Annex 1 Responses to Information Requirements

Federal Indigenous Review Team (FIRT) – Denison's Responses to Information Requirements for the Wheeler River Project Environmental Impact Statement

Annex 1 – FIRT IR Table – Technical Review of the **Wheeler River Project** draft EIS Denison Response - August 18, 2023

Figure IR195-1: Modelled Concentrations of COPCs in Water during Project Phases

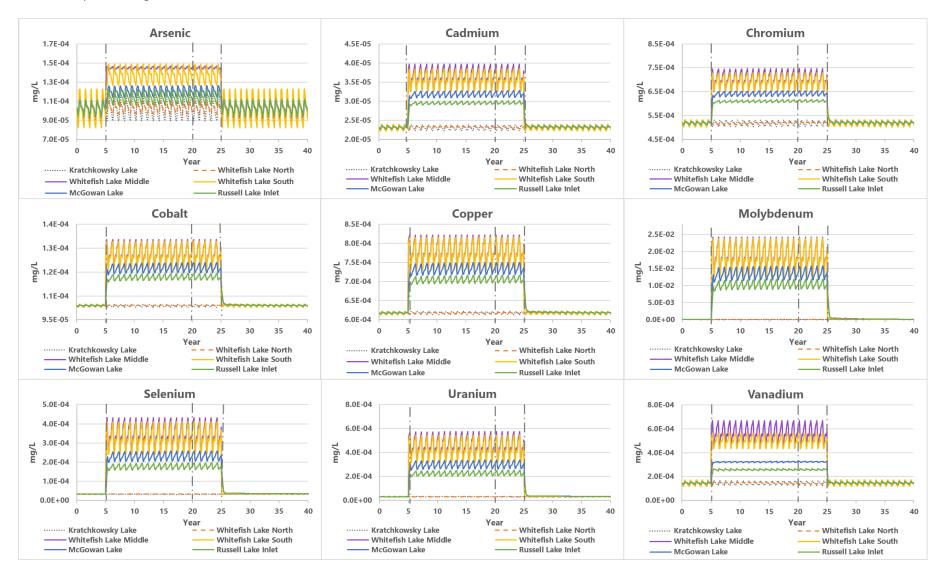
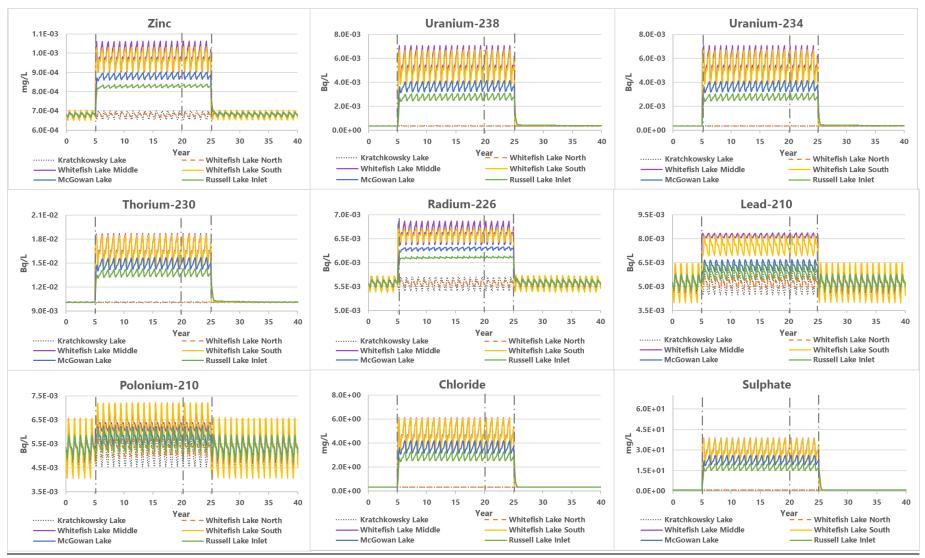
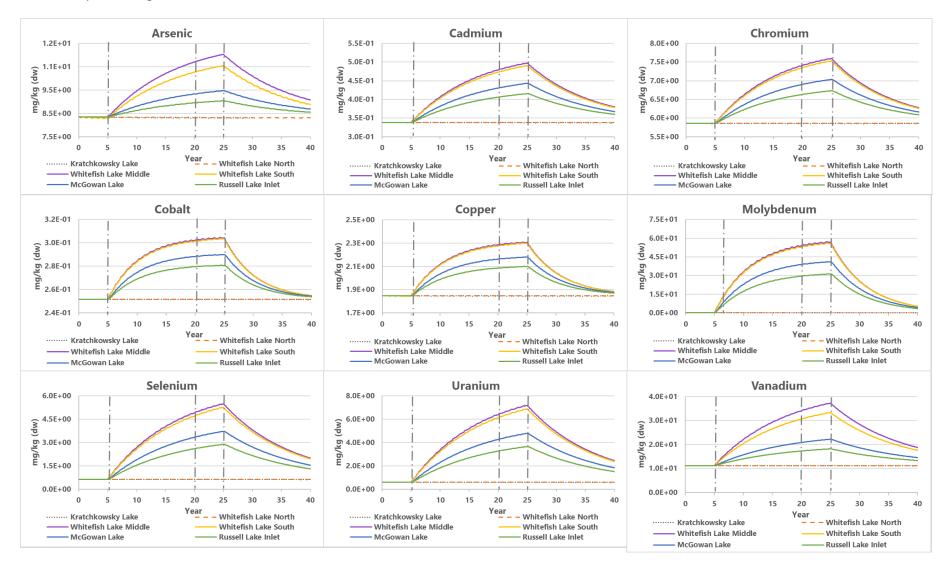
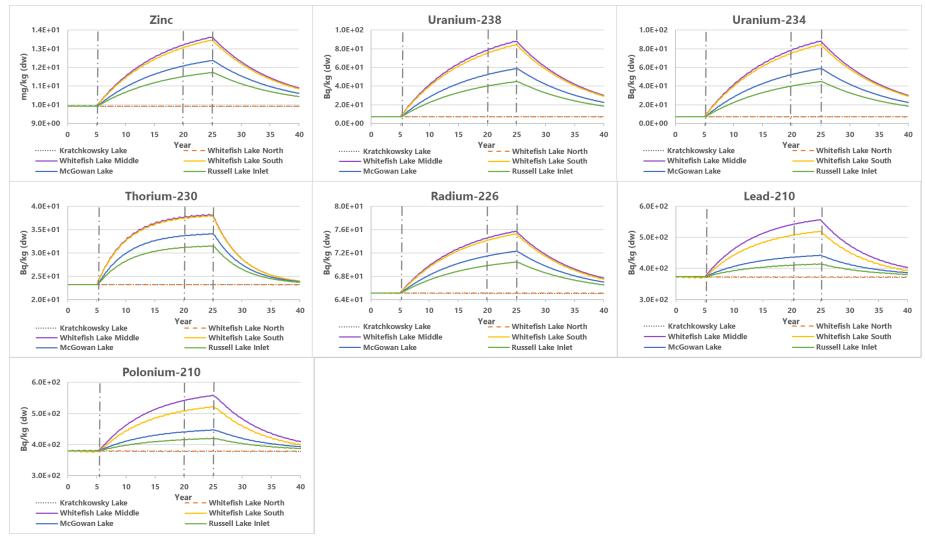
IR-195	ECCC	Change to an environmental component due to hazardous contaminants	Appendix 10-A (ERA), Section 3.1.2.1	Context: Figure 3-2 depicts modelled concentrations of COPCs in the receiving environment surface water during all Project phases. Effluent discharge rates during Operations and Decommissioning are not anticipated to differ significantly. However, COPC concentrations seem to decrease rapidly after the end of the operations period despite effluent releases continuing into the decommissioning phase. Rationale: There has been no information provided on predicted changes in effluent COPC concentrations and discharge rates during the decommissioning phase. It remains unclear how COPC concentrations would decrease so quickly following the end of operations.	 Provide further information on modelled maximum COPC concentrations for each individual Project phase with estimated timing for peak concentrations to appear in the receiving environment. Provide further information on predicted effluent quality during the Project decommissioning phase. Update ERA figures and conclusions as needed. 	 Per the draft EIS effluent is conservatively assumed to be discharged to the Whitefish Lake Middle during the operations (15 years) and decommissioning (5 years) phases at the same constant discharge rate of 36.5 m³/hr (10.1 L/s) with the same stable effluent quality as shown in Table 3-2. Therefore, the modelled maximum COPC concentrations in water are the same for operations and decommissioning phases (which is considered conservative), the same peak concentrations appear annually due to the variation of the monthly local inflow. Since COPCs are accumulated in sediment, the modelled maximum COPC concentrations in sediment appear at the end of each individual Project phase, which are year 20 for the operations and year 25 for the decommissioning in Figure 3-3. The predicted effluent quality during the Project decommissioning phase is expected to be the same as those during the operations. Effluent was set to be released during operations but not during the decommissioning phase in the current model. The model has been updated to include effluent discharge during the decommissioning phase, and the ERA figures and result tables will be updated in the next submission 	Per the IR response, edits will be made to Table 3-3 and Figure 3-2 in Appendix 10-A. These edits are provided in Attachment IR-195.
